INDE. 216
CRBIB#002027
391/132024
HISTORIC STRUCTURES REPORT

Restoration of Roof Balustrade

Independence National Historical Park
January 1964

Historic Structures Report, Part II (Portion)
Restoration of Roof Balustrade, Independence Hall (Architectural Data Section)

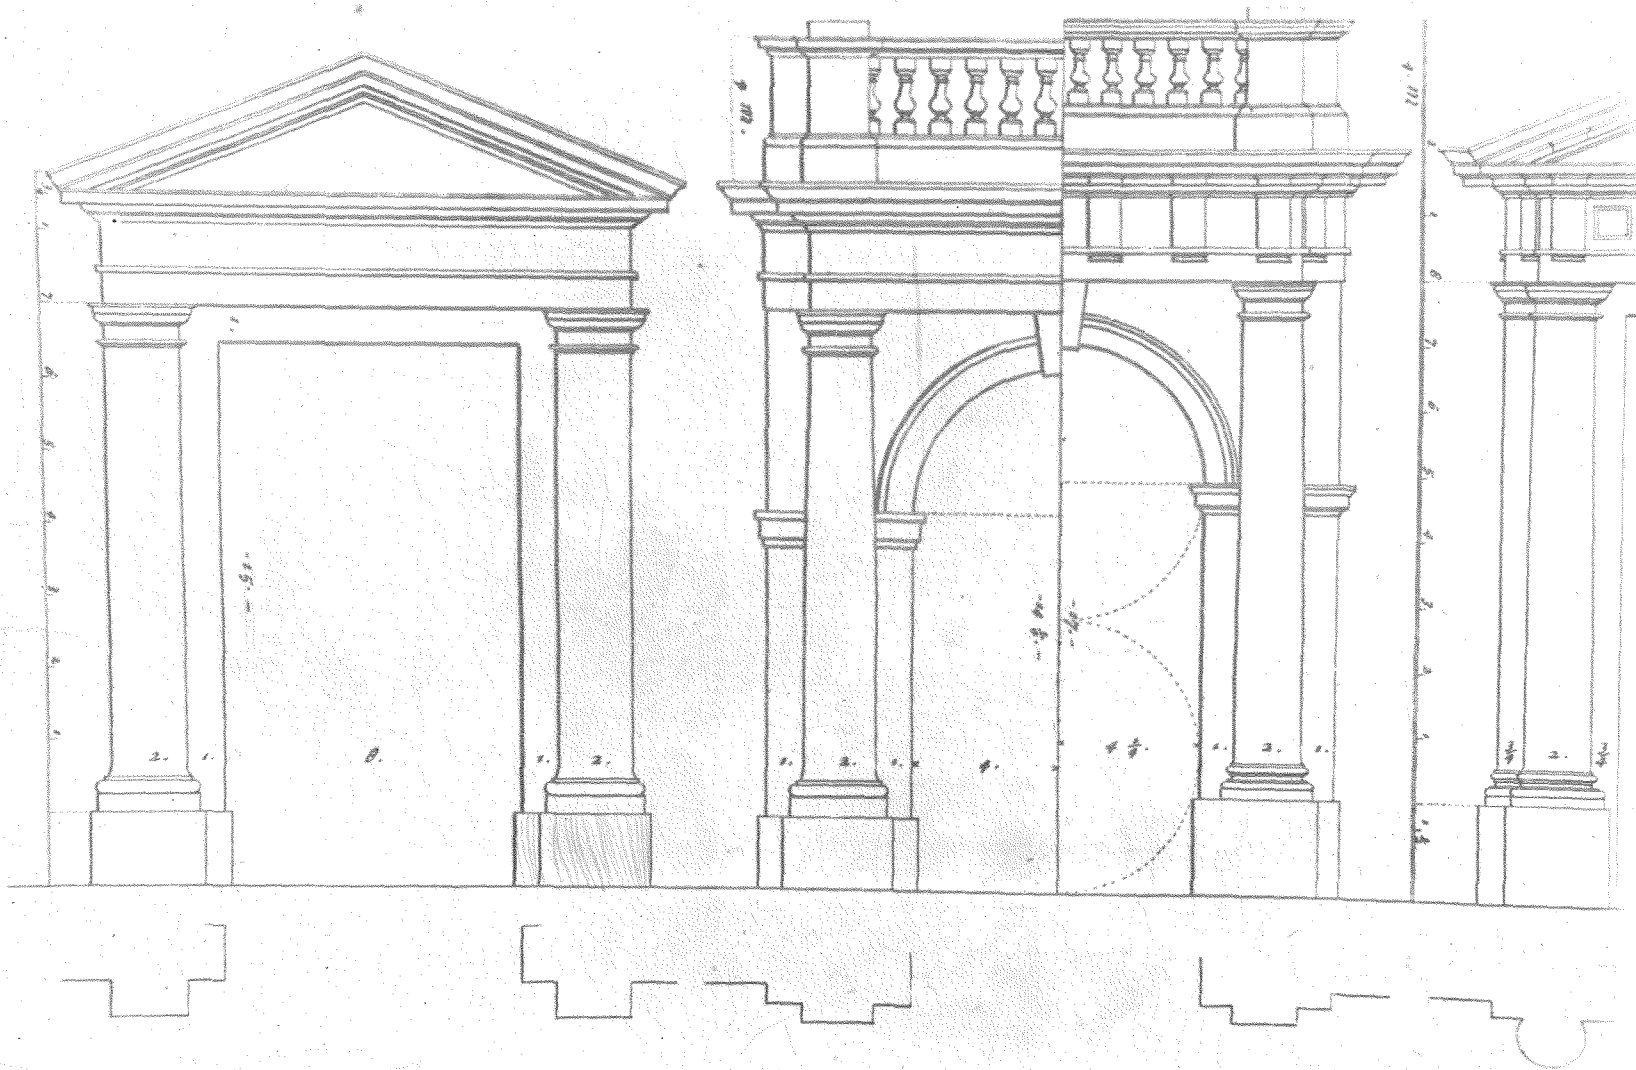
1. Why ignore the State-House detail in Peale's portrait of Girard c 1778?
2. The Read (1774) and Scull & Heap views, which Dysert accepts, agree in showing 10 bays. So does the Davies (1794) which certainly wasn't copied from either Scull & Heal or Read. The Peale, because of the perspective, does not show the entire ballustrade, but is not inconsistent with 10 bays.

The Read shows 4 ballusters per bay, the other 3 views agree on 5.

The Birch (1804) is a 19th Century View, and Birch is not too careful with detail.

Thus - of the three views nearest 1776 (1753, 1774, 1778), two show and one appears to show a ballustrade of 10 bays.

Two, including the Peale, show 5 ballusters per bay.

Thus, the weight of the only pictorial evidence of the ballustrade as it was in 1776, indicates a ballustrade of 10 bays, 5-ballusters per bay.

Each of these, and the Birch as well, show the ballustrade to be roughly 1/2 the height of the chimneys.

Admittedly, the details are not clearly shown.

It is recommended to restore a ballustrade of 12 bays, 8 ballusters per bay. The details of this ballustrade are known.

What then do we do - restore the 10 bay, 5 baluster ballustrade shown to have been there in 1776, guessing at detail, or the 12 bay, 8 balluster ballustrade of 1828, with known details?

The average visitor will view the restoration from the ground, can note only proportions, number of bays and number of ballusters per bay, and will never be able to see the construction details.

Jubles, 1728 ed., pl. 23

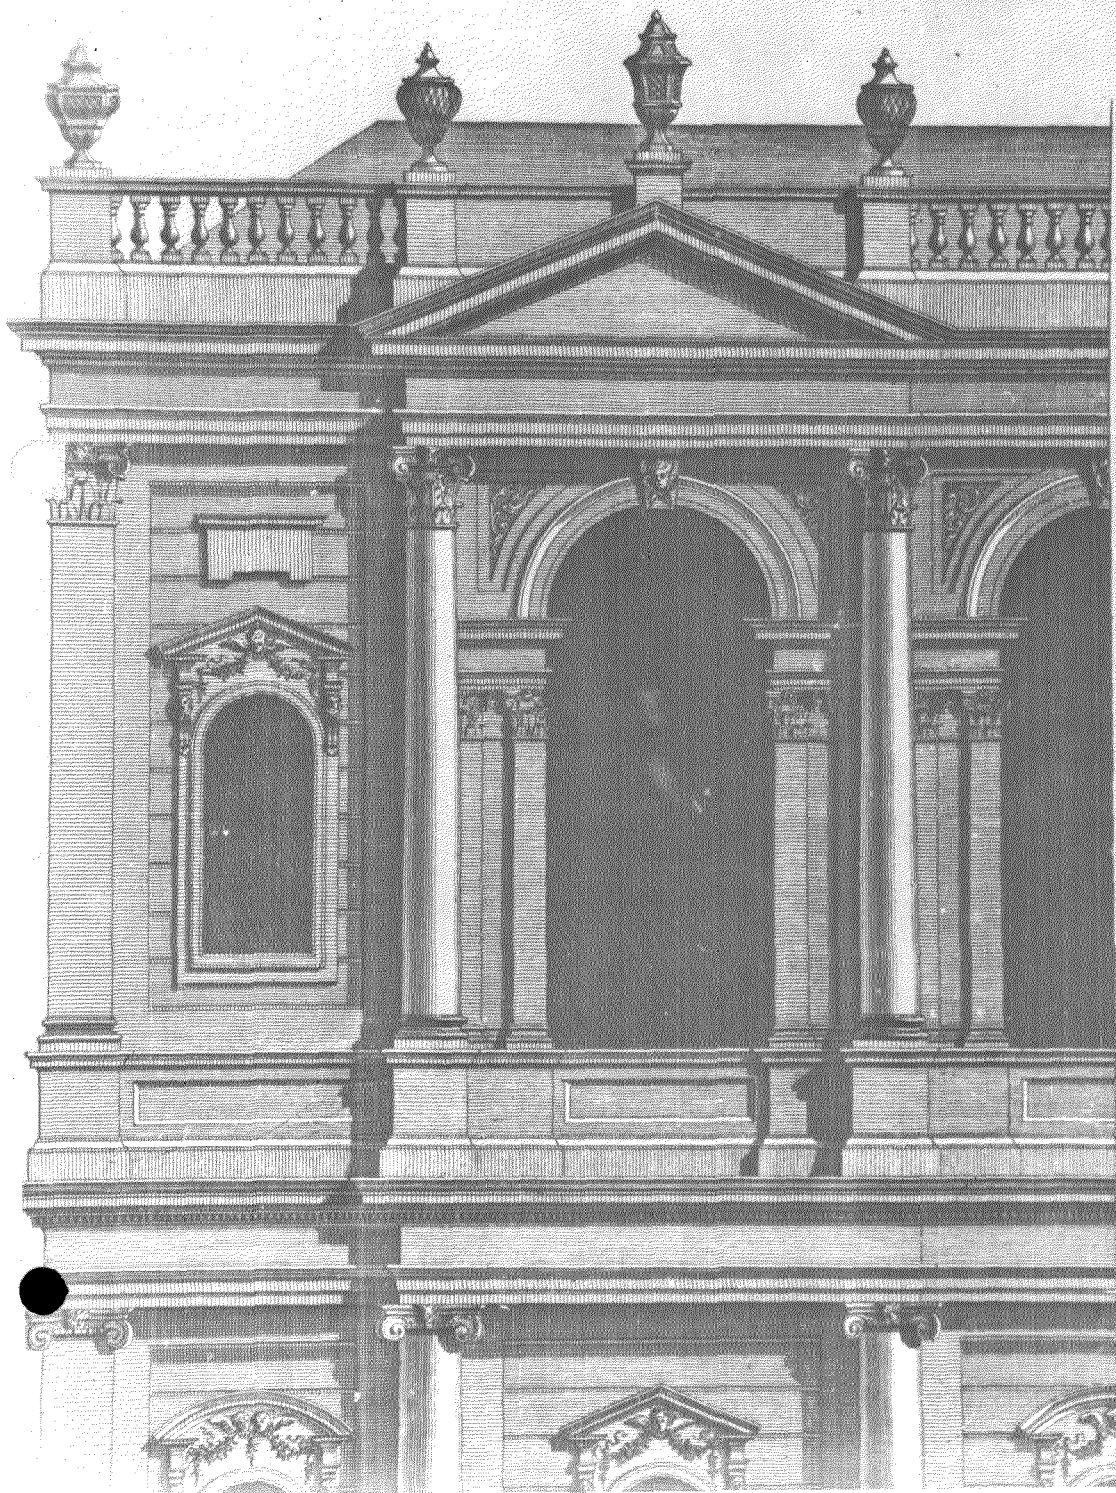
This treatment is consistent with Gibbs' practice in the church shown on plate 23 of his Book of Architecture. Significantly too, the builders of Christ Church regulated the proportion of the height to the spacing of the balusters by inserting a die next to the pedestal, at each end of the bay or range of balusters.
